**Application Recommended for Approval
Cliviger With Worsthorne**

FUL/2023/0036

New build detached house to be built on land at number 4 Lindsay Park
4 Lindsay Park, Worsthorne-with-Hurstwood, Burnley BB10 3RR

Proposed Elevations

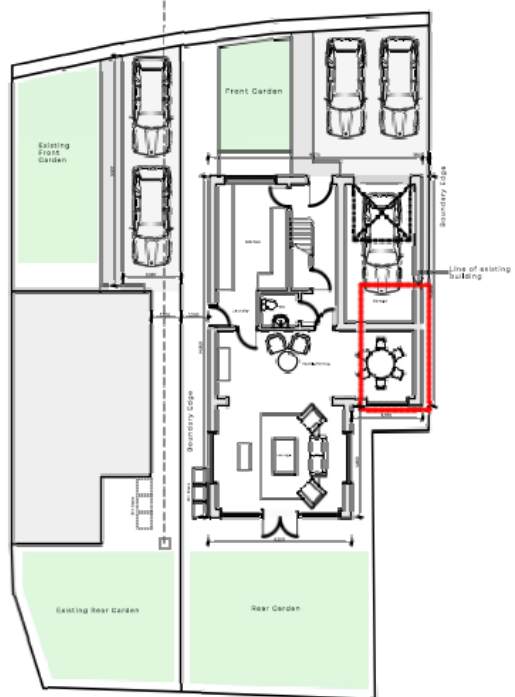
- ii. A bathroom window at 1st floor level to face the rear garden of No. 2 Lindsay Park at 0.290m distance to boundary. Whilst it is highly likely that this window would be obscure glazed as a matter of course, it is recommended that a condition requiring this window to be obscure glazed to at least Pilkington III standard, and be so retained is imposed to prevent intrusive views into the garden of No.2.

Landing window will overlook the rear garden of No.2 Lindsay Park directly. Amended plan shows this as a bathroom window. A Condition is recommended to ensure that it be obscure glazed and so retained.

10. Notwithstanding details shown on submitted plans, the windows facing north-west and south-east in the single storey element to the rear of the dwelling, plus the window identified as 'bathroom' in the north-west facing elevation shall be glazed using obscured glass to a minimum of level 3 of the "Pilkington" scale of obscuration. And those windows shall remain so glazed (Note the application of translucent film to clear glazed windows does not satisfy the requirements of this condition).

'Average' Shadowing Diagram

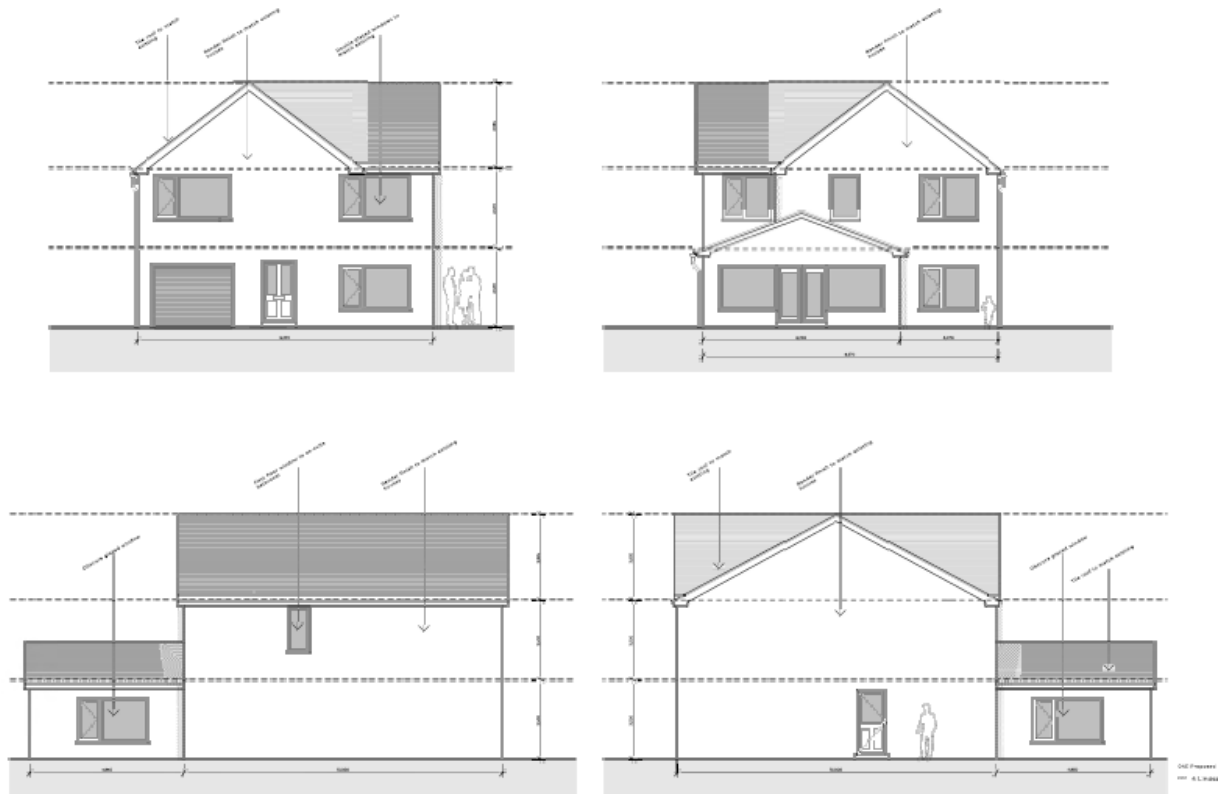
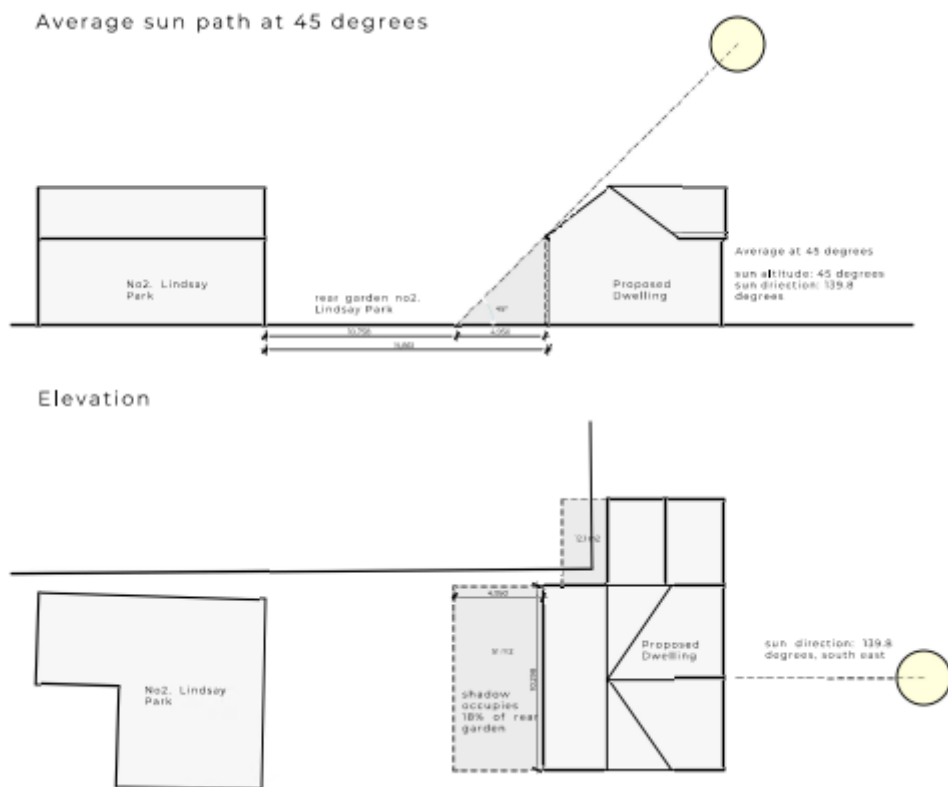
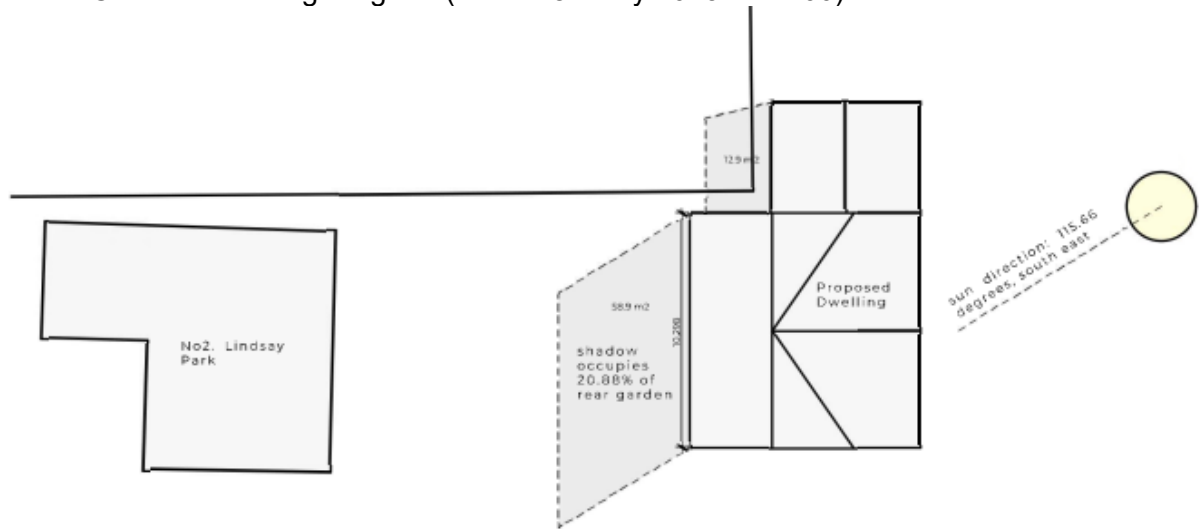
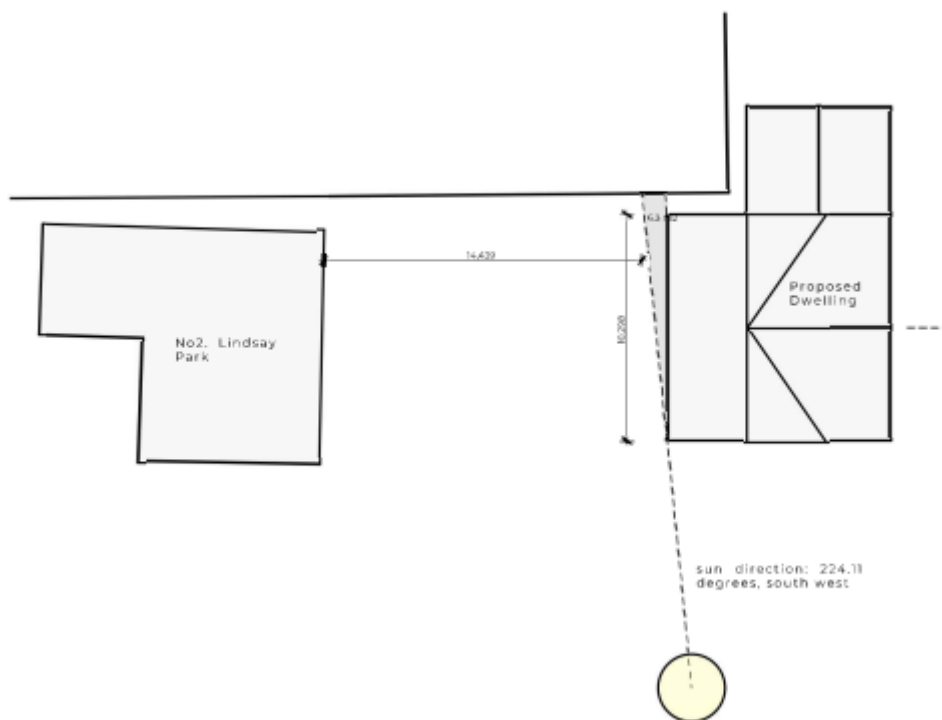
Potential overshadowing of the rear garden of No.2 Lindsay Park also needs to be considered. The application contains diagrams that estimate levels of overshadowing, and they do indicate that approx. 20% of the rear garden of No.2 will be affected by shade-cast in the worst case scenario. The new dwelling lies to the East and the impact will diminish as the sun moves throughout the day.

If the amount shown on the diagrams is correct, the cast will be on the rear part of the garden only and very much on balance not of sufficient detriment to warrant refusal of the planning application. It should be noted that that the application has been amended since submission from one with a conventional gable facing no.2 Lindsay Park to one with a hipped roof facing No.2, specifically to reduce potential overshadowing of the back garden.

Objector's measurements

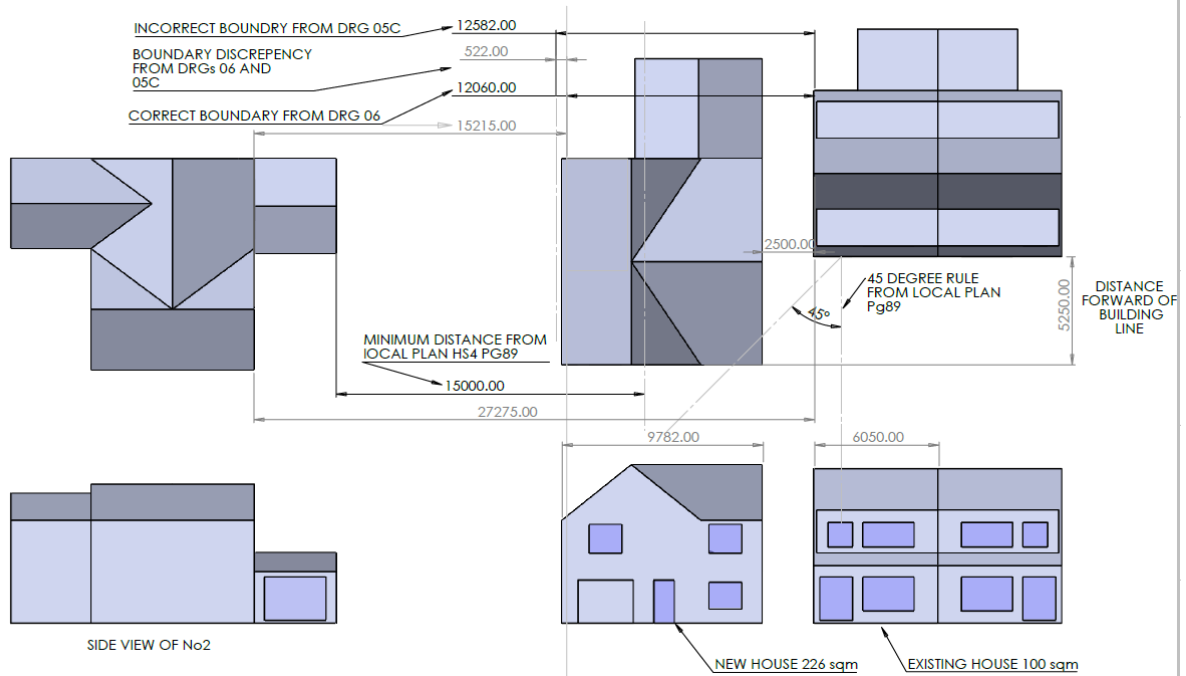
Inaccuracies in measurements on submitted plans.

Inaccuracies in measurements on submitted plans. The Case Officer checked disputed dimensions on site and an amended plan was subsequently submitted.
